**SUBJECT:** Response to NRC Requests for Additional Information Regarding License Amendment Request for Leak-Before-Break of the Pressurizer Surge Line Waterford Steam Electric Station, Unit 3  
Docket No. 50-382  
License No. NPF-38

**Response to NRC Requests for Additional Information for License Amendment Request  
Regarding Leak-Before-Break of the Waterford 3 Pressurizer Surge Line**

Figure 1: CASS Stress-Strain Curves from PIFRAC Database

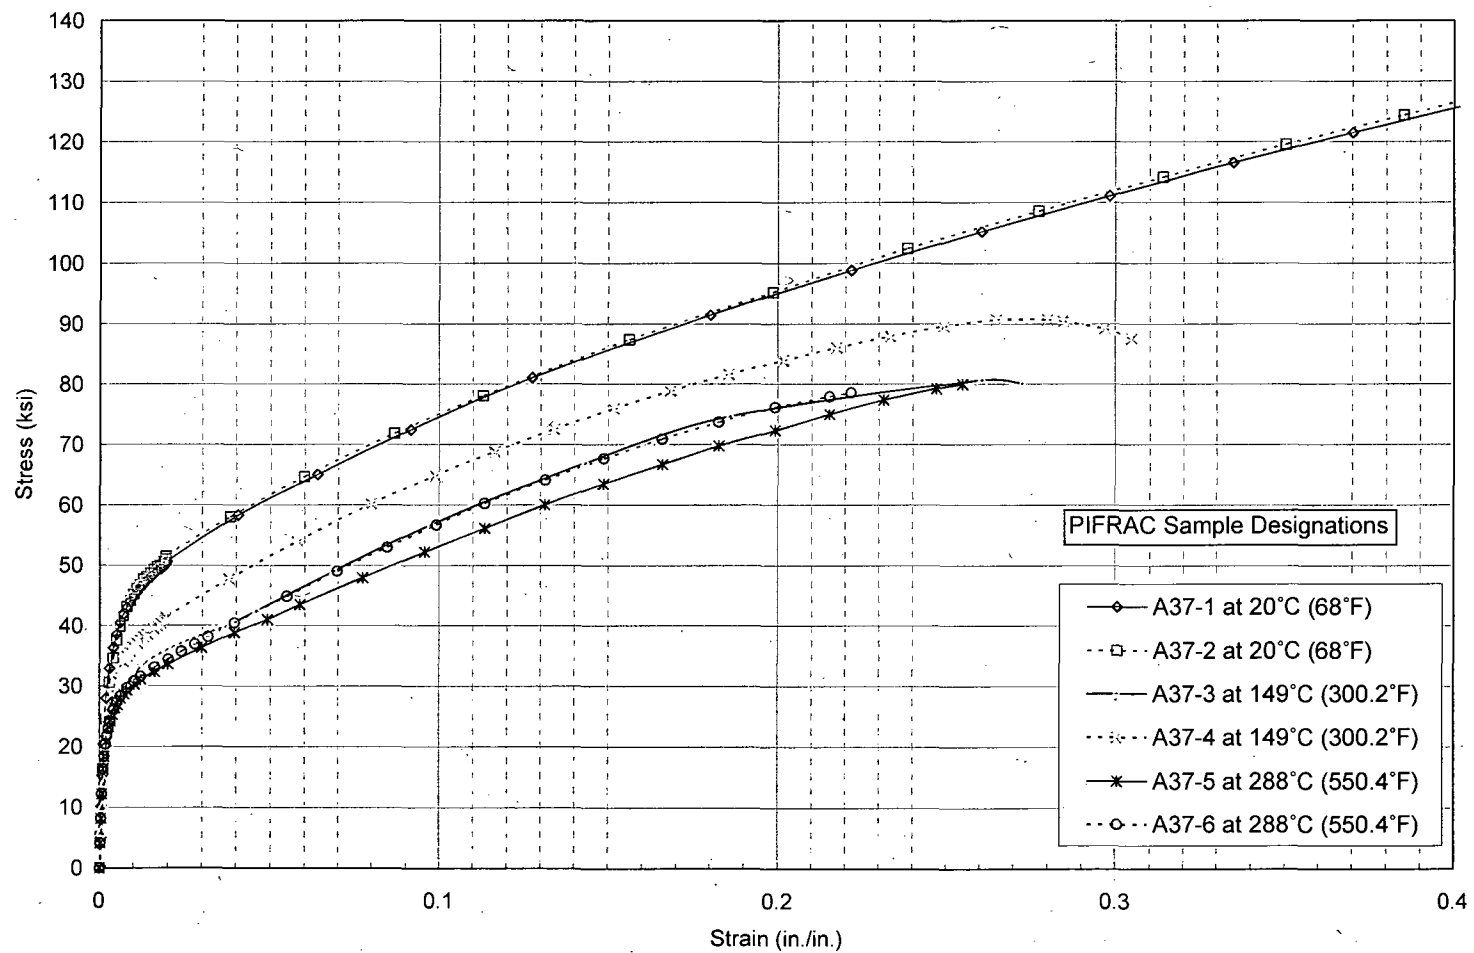
**RAI R-9 (Round 2)** The response does not answer the question. The staff suggests that the Battelle data (both at room temperature and operating temperature) that corresponds to the Certified Material Test Report (CMTR) for this material be used.

**Response:** The NRC Battelle report on PIFRAC material database, "Pipe Fracture Encyclopedia" (Volume 1, 1997) has stress-strain properties for CASS base materials at temperatures of 20°C (68°F), 149°C (300°F), and 288°C (550.4°F). A plot of the true stress-strain data for PIFRAC samples A37-1 through A37-6 is shown in Figure 1 below. This data includes two samples at each of the three temperatures. The strain range of interest for the LBB applications is from 0% to 5%. This material data is approximated using the Ramberg-Osgood (R-O) law equation:

This form of the material curve idealization has limited parameters to represent the actual material stress-strain curves. In the low strain range of interest, the data in Figure 1 shows similar trends with temperature. The room temperature curve was applied to fit the R-O law, then used for all temperatures of interest keeping the

The yield stress inferred from the PIFRAC data was compared to the yield stress for the actual surge line materials. It was observed that the room temperature yield strength of the CASS material in PIFRAC is significantly lower than the CMTR values of the actual material. Also, the yield stress from the limited amount of PIFRAC data variation with temperature is inconsistent and has no trend, as the data at two higher temperatures, 149°C and 288°C, are almost identical and do not show any temperature variations. The trend of yield stress of the PIFRAC samples with temperature was not smoothly decreasing as expected. For these reasons, the PIFRAC data cannot be used directly. However, the shape of stress versus strain as represented by the R-O law fit curve can be scaled to the CMTR yield stress at room temperature. Then, the curves at higher temperatures are obtained by scaling the room temperature curve by the ratio of the ASME Code yield stress at the evaluation temperature over the yield strength at room temperatures.
